Office Action Summary

10/586,069

FUKUSHIMA, SUSUMU

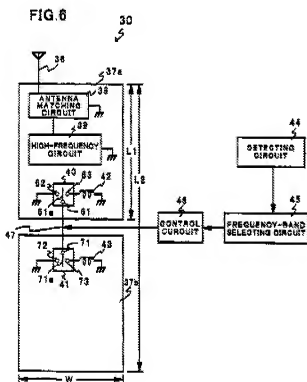
Ueda disclose in figure 6, a cellular phone comprising an antenna 36; a high-frequency circuit 39 connected via a matching circuit 38 to the antenna; a first printed substrate 37a which comprises a first ground section connected to the high-frequency circuit; a reactance circuit comprising inductors 42 and 43, wherein inductors 42 is connected to the first ground section; and a second printed substrate 37b which comprises a second ground section connected to the reactance circuit.

The cellular phone, further comprising a frequency band selecting circuit which examiner considers to be a transmitter-receiver; and a cable for connecting between the terminals (62-63 and 72-73) of the switches 40 and 41. The terminals (62, 63) are connected to the first ground section while the terminals (72, 73) are connected to the second ground section. Therefore, the cable provides connected between the first ground section and the second ground section and the frequency band selecting circuit.

The reactance circuit includes inductors 42 and 43 and a switches 40 and 41 for switching the inductors.
